Intersection ID: 16358	Main Street: BILLINGSLEY_RD	Cross Street: ELLINGTON_ST	Location:	NE
ADA ID: 7FC35CEE48BE	Ramp Type: PerpDiag	Initial Pass/Fail: Fail	Overall Compliance: No	Severity Score: 21.25

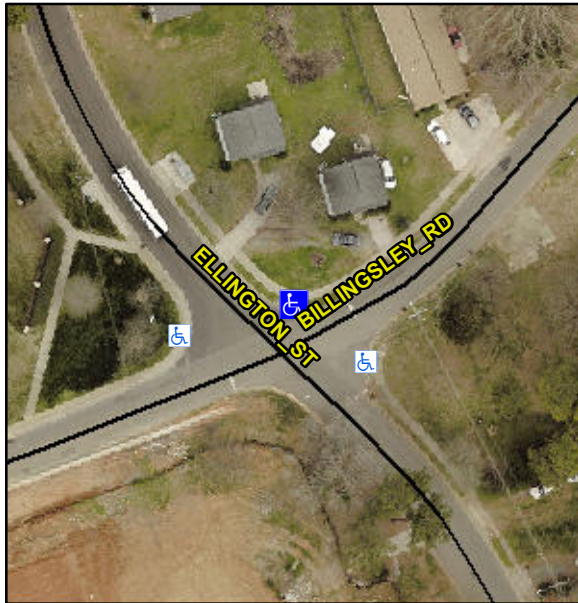
Not Found, R304.5.1, R304.2.2

Compliance	Description	Data	Compliance	Description	Data
N/A	Ramp Length (in)	48.0	No	Ramp Slope (%)	8.6
No	Ramp Width (in)	44.0	Yes	Ramp XSlope (%)	0.8
N/A	Flare Type LT	N/A	N/A	Flare Type RT	N/A
N/A	Flare Slope LT (%)	N/A	N/A	Flare Slope RT (%)	N/A
N/A	Flare Traversable LT?	N/A	N/A	Flare Traversable RT?	N/A
N/A	Landing Length (in)	N/A	N/A	DWS Provided?	N/A
N/A	Landing Width (in)	N/A	N/A	DWS Contrast?	N/A
N/A	Landing Slope (%)	N/A	N/A	DWS Length (in)	N/A
N/A	Landing X Slope (%)	N/A	N/A	DWS Full Width?	N/A
N/A	Landing Curb? (Y/N)	N/A	N/A	DWS Offset (in)	N/A
N/A	Shared Landing?	N/A			
N/A	Gutter Ponding?	N/A	N/A	Gutter Slope (%)	N/A
N/A	Gutter Lip Ht (in)	N/A	N/A	Gutter X Slope (%)	N/A
N/A	Painted X Walk1?	No	N/A	Painted X Walk2?	No
	X Walk 1 Direction	To SW		X Walk 2 Direction	To SE
N/A	X Walk 1 Width (in)	N/A	N/A	X Walk 2 Width (in)	N/A
	X Walk 1 Slope (%)	5.3		X Walk 2 Slope (%)	8.0
	X Walk 1 X Slope (%)	6.6		X Walk 2 X Slope (%)	4.8

Remove & Replace Curb Ramp With Two New Directional Ramps or Equivalent.
